UNITED STATES PATENT AND TRADEMARK OFFICE

APPLICATION NO.	FILING DATE	FIRST NAMED INVENTOR	ATTORNEY DOCKET NO.	CONFIRMATION NO.
10/042,998	04/12/2002	David N. Armstrong	10148-1020	6172

**Office Action Summary**

**FIG. 6**

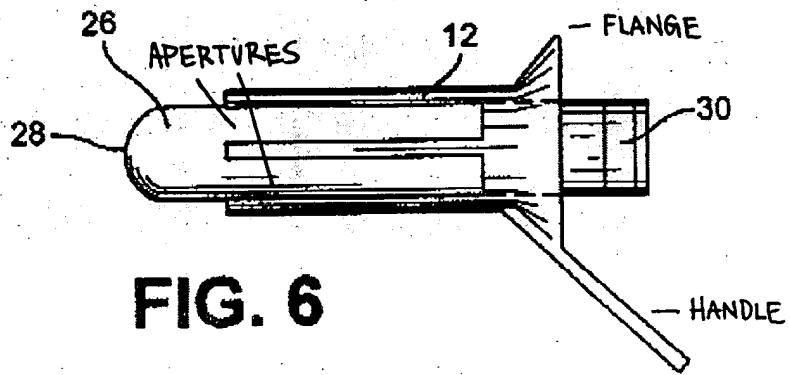
9. Regarding claim 28 and 29, the Watson ligator anticipated all the limitation of these claims. The examiner has attached a sheet labeling all of the corresponding

parts. Inner cylinder is element 1, outer cylinder 2, central rod 3, outer rod 4, and handle 5.

12. Regarding claim 32, the disposable cylinder is labeled on the attached figure as element 6. The shoulder is the element that pushes the band off of the cylinder (7).
